June 8, 2020.

Rosehill Reservoir Rehabilitation: The New Plan for David A Balfour Park

VALVE HOUSE NODE, NEAR SUMMERHILL ENTRANCE/LITTLE PARK

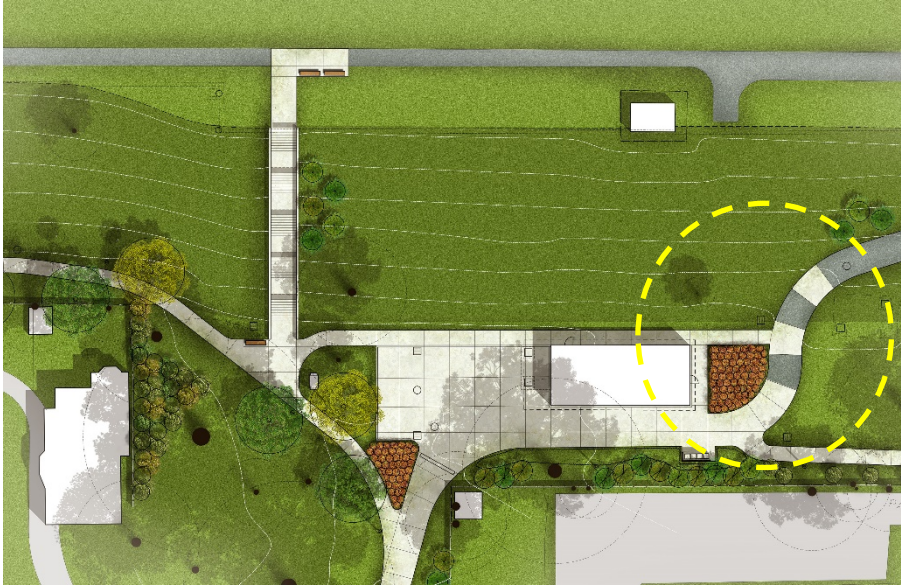
The design for the node around the Valve House has removed a south-facing trellis and added an "S" curve to the path alignment at the east side of the building (yellow circle).
